**NMD-71-5
Revision 1**

SUBJECT: NOMAD SERVICE BULLETIN NMD-71-5 REVISION 1

SUBJECT: ENGINE NACELLE LOWER COWL - REPAIR

LOWER COWL ASSEMBLY
REPAIR SCHEME
FIGURE 1

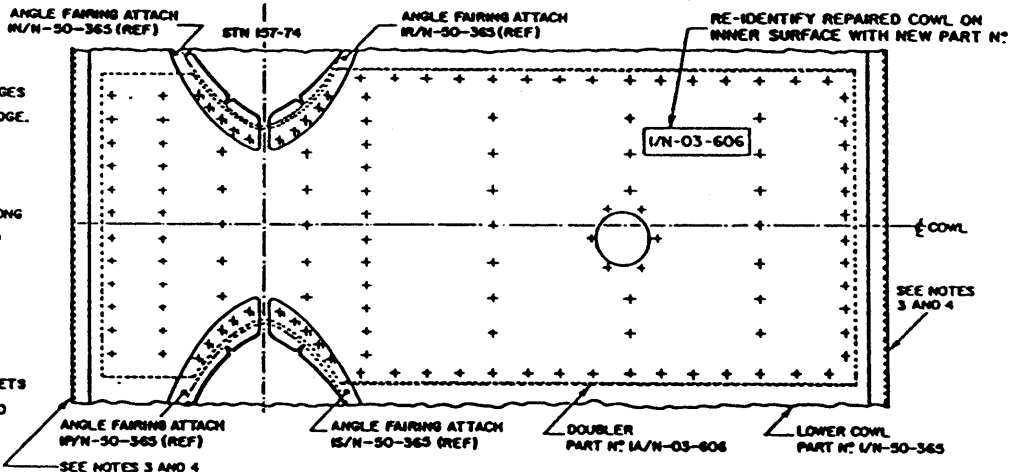
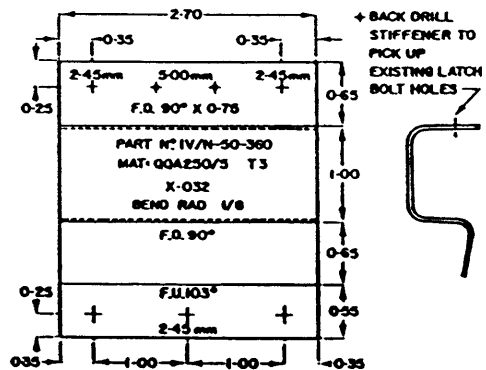
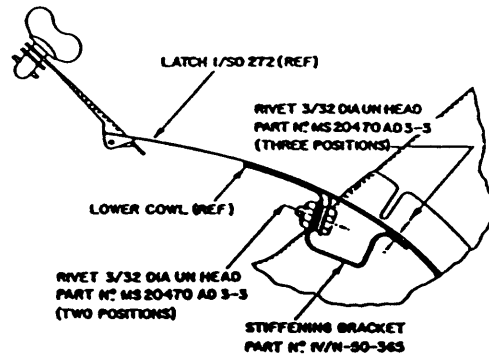
(9) Page 8 Figure 1 Note 4

Reference to BETA 1722 contact adhesive deleted.

- 1 STRIP PAINT FROM LOWER COWL 1A/N-30-363 FRONT AND REAR EDGES A DISTANCE OF 0-625 FROM THE EDGE.
- 2 REMOVE SHARP EDGES.
- 3 APPLY BROUILLET N°4 EDGING ALONG THE FULL LENGTH OF FRONT AND REAR EDGES.
- 4 ADHERE WITH PR1421 OR PR1422 SEALANT.
- 5 DOUBLER TO PICK UP EXISTING RIVETS WHICH ATTACH ANGLE FAIRINGS TO LOWER COWL.
- 6 POSITION DOUBLER 1A/N-03-606 CENTRALLY AS SHOWN.
